EXPLANATION OF SIGNIFICANT DIFFERENCES

Sitcum Waterway Problem Area of the Commencement Bay Nearshore/Tideflats Superfund site, Tacoma, Washington. Operable Units 01 and 05--Contaminated Marine Sediments and Sources, respectively.

The purpose of this ESD is to provide information concerning the remedial action to address contaminated sediments in the Sitcum Waterway Problem Area of the Commencement Bay Nearshore/Tideflats (CB/NT or Commencement Bay) Superfund site. This ESD also explains the differences between the remedial action and the cleanup plan described in EPA's September 30, 1989, Record of Decision (ROD) for the CB/NT site.

FIGURE 1

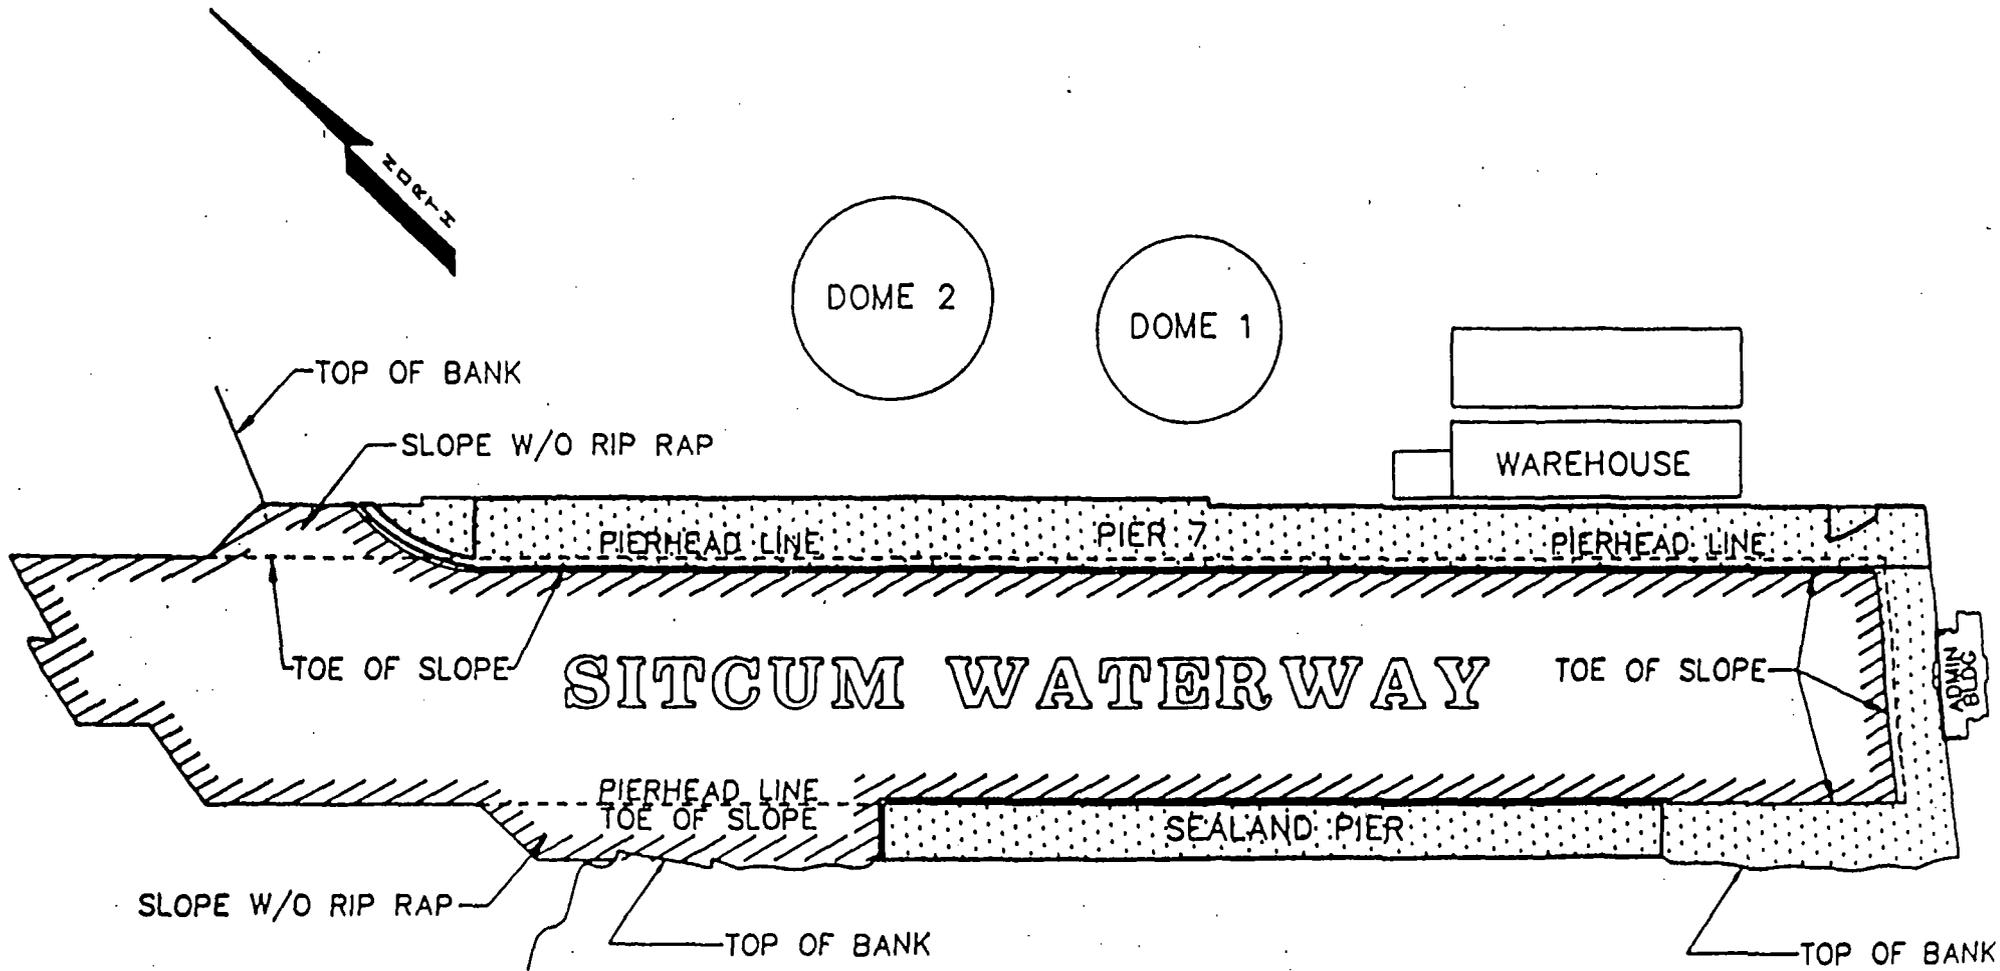
See figure 1 for the map that delineates Phase 1 channel sediments and Phase 2 peripheral sediments. Description of the Phase 1 and Phase 2 areas follows:

Phase 1 area is the bottom sediment of Sitcum Waterway, limited on three sides by the existing rip rap at the toe of the banks and at the mouth of the waterway where the existing channel bottom drops off to the deeper portions of the Bay. Also included in Phase 1 are the slopes which have no rip rap and are located bayward of the existing Sea Land Pier and the northwestern rail trestle leading to Pier 7.

Phase 2 area is the rip rap covered existing slopes, both exposed and under pier. The slopes are from the bay end of the Sea Land pier to and including the head of the waterway, and all slopes under Pier 7 including those surrounded by the rail trestles at each end of the pier.
